PICKER CORPORATION

Ref: Certificate of Compliance 9011 and  
the corresponding IAEA Certificate  
of Competent Authority, USA/9011/B

After reviewing our Certificate of Compliance 9011 and the corresponding IAEA Certificate of Competent Authority for the Picker Overpack, MEH-00-00004, a discrepancy in the package description was detected. The two certificates indicated 36" x 36" x 41" dimensions. The actual dimensions are 36" x 42" x 40.5". Seven copies of the 10 sheet drawing, MEH-00-00004, are attached. Sheet 1 of 10 depicts the overall dimensions. Our original application also specified the 36" x 42" x 40.5" dimensions.

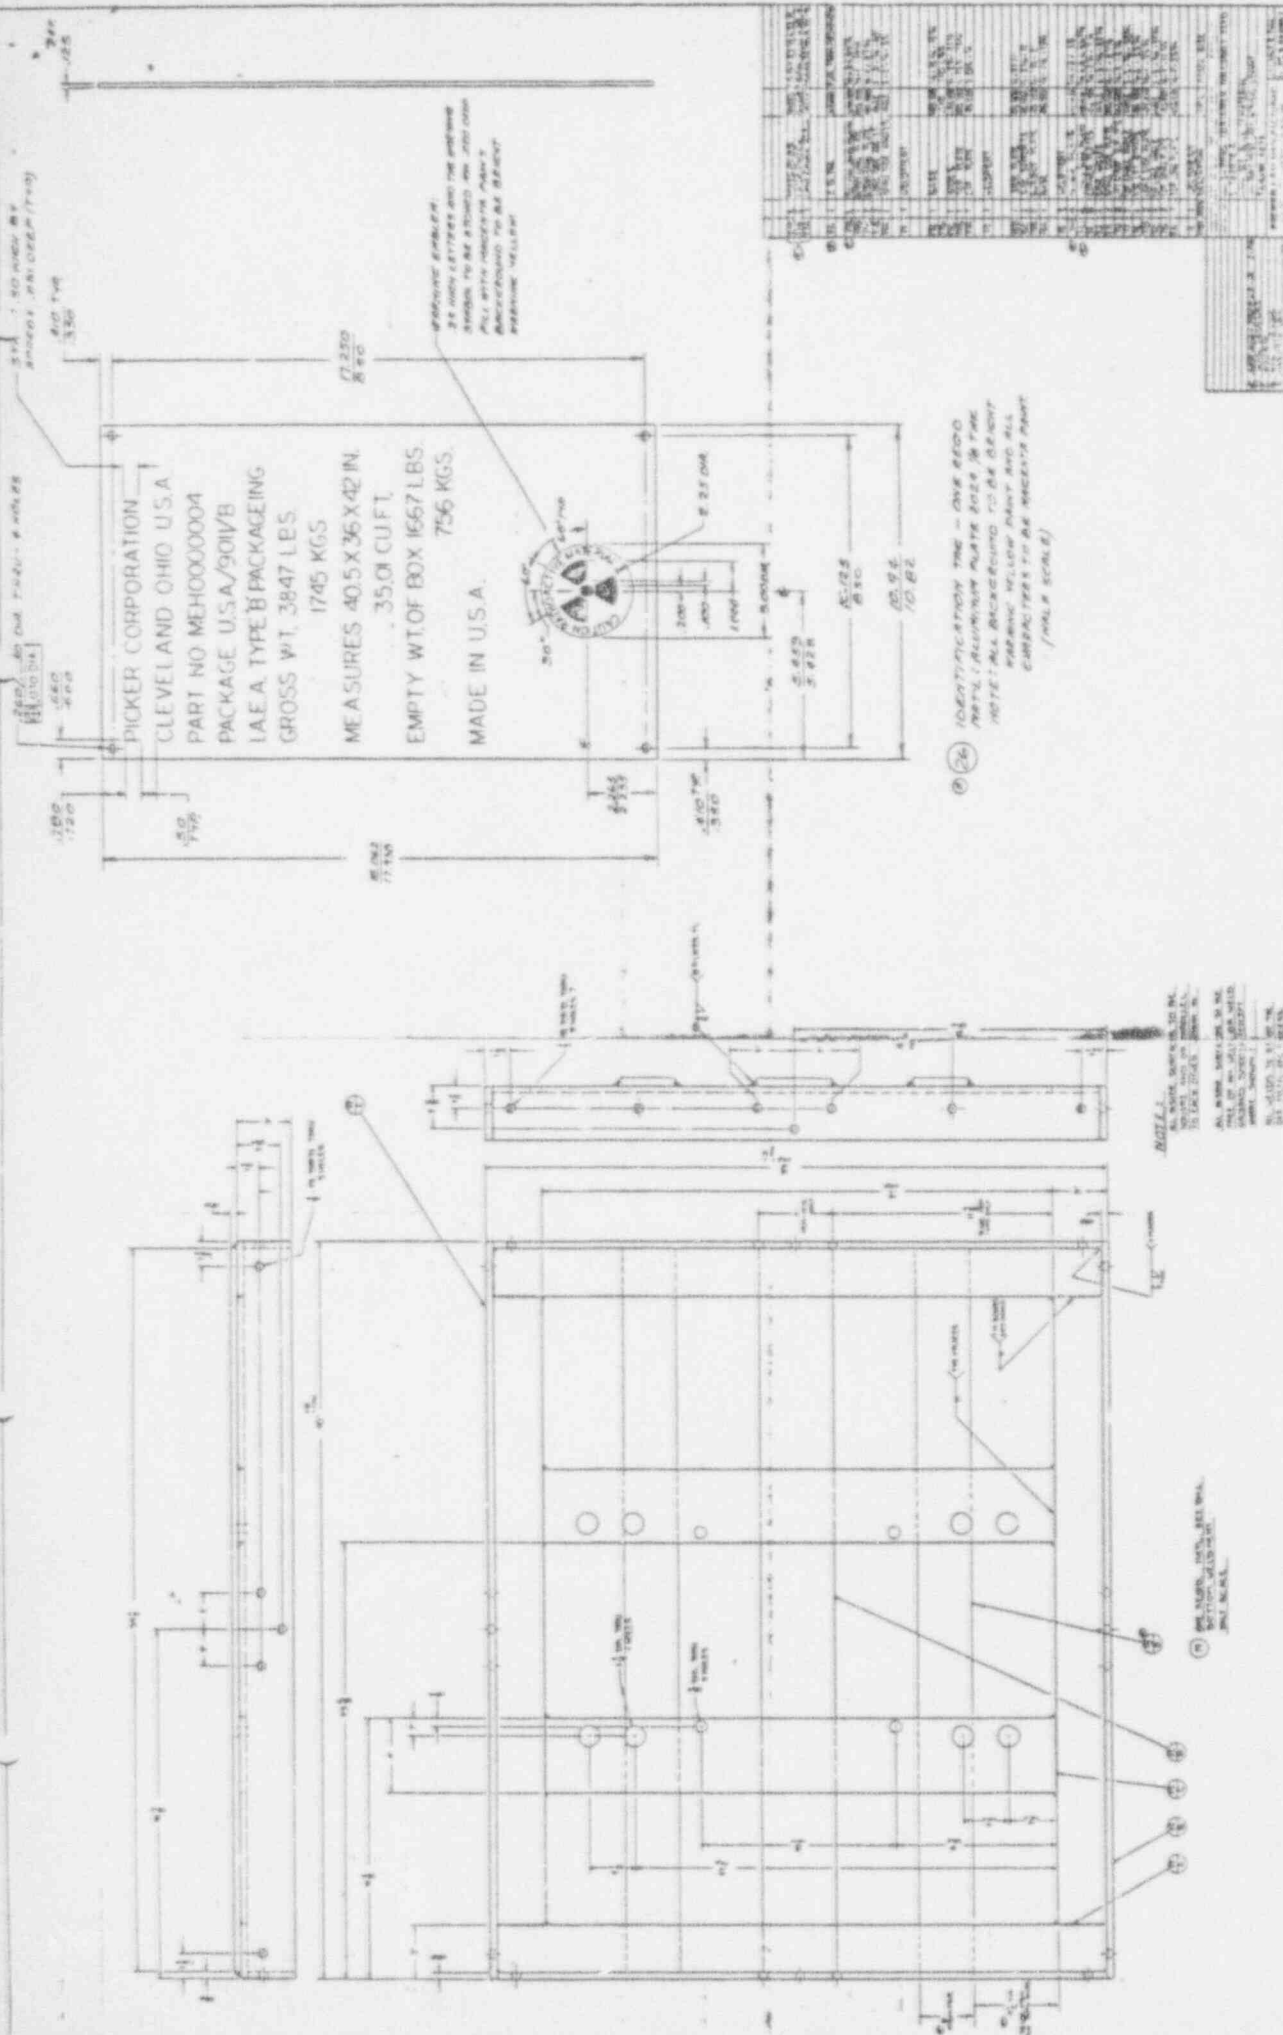
Also note that we have revised the identification tag, which appears on sheet 10 of 10, to incorporate the USA/9011/B package identification number and the trefoil "Radio-active Material" symbol.
